SERVICE BULLETIN

CRACKS, WEAR AND DISTORTION ON THE CARBURETOR FLANGE ON ROTAX[®] ENGINES TYPE 912 AND 914 (SERIES)

SB-912-030 R1

SB-914-019 R1

Fig. 1

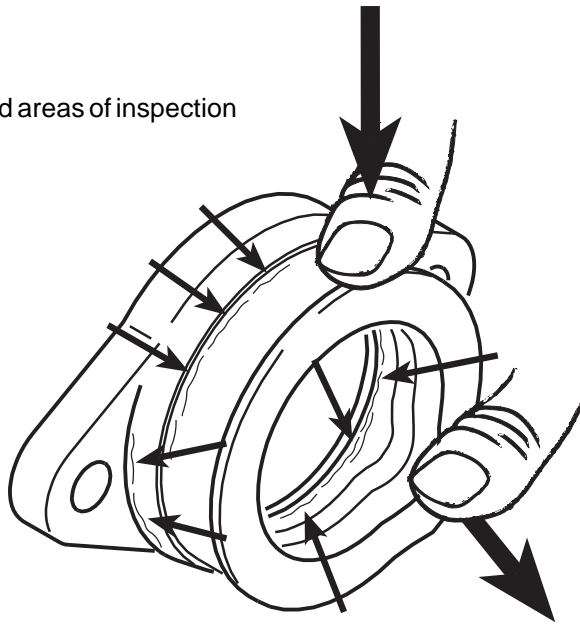
Inspection of the carburetor flanges in accordance with the relevant Maintenance Manual and the information contained in Section 4) Appendix, Figure 1 .

Recommended areas of inspection

- Within the next 10 hours of operation the carburetor flanges must be inspected for damage, cracks, wear and distortion according to the following instructions in section 3. Replace with part no. 267788 as required.
- Every 50 hours of operation the carburetor flanges must be inspected for damage, cracks, wear and distortion according to the following instructions in section 3. Replace with part no. 267788 as required.

carburetor flange old

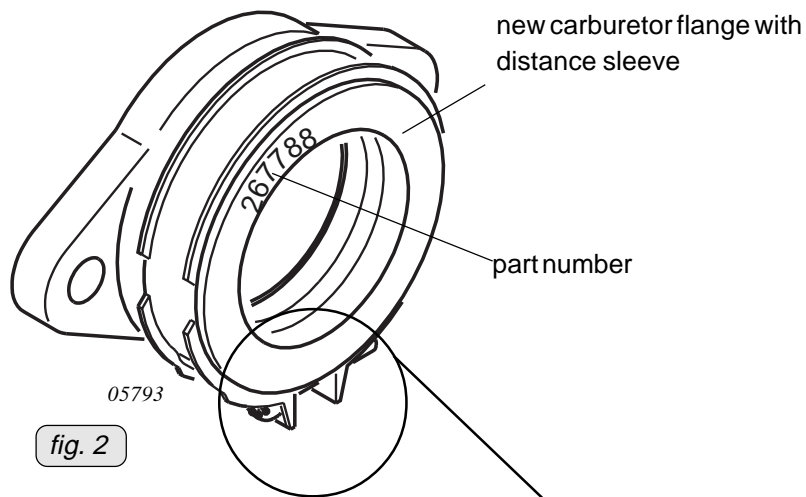
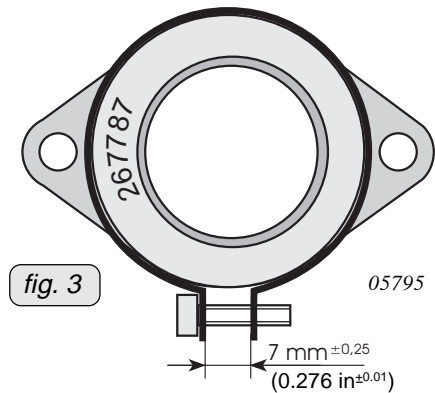
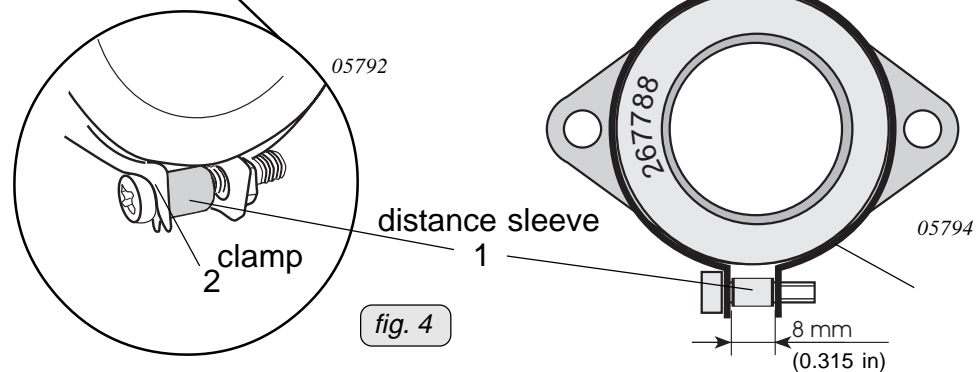
Introduction of a optimized carburetor flange with improved strength properties and spacer for the clamp. One or more of the following could result in increased stress and consequently in damage of the carburetor flange assembly:

* ▲ **WARNING:** Due to differences in spacing **don't use** the distance sleeve (1) included in delivery of the carburetor flange part no. 267788 in combination with the carburetor flange part no. 267787.

▲ **WARNING:** **Don't use** aluminum insert included in delivery of the carburetor flange part no. 267785 or 267780 in combination with the carburetor flange part no. 267788.

Replacement/Installation of the carburetor flanges in accordance with the relevant Maintenance Manual. Tighten clamp (2) of the carburetor flange part no. 267788 with tightening torque 2.5 Nm (22 in.lb) (see fig. 4) .
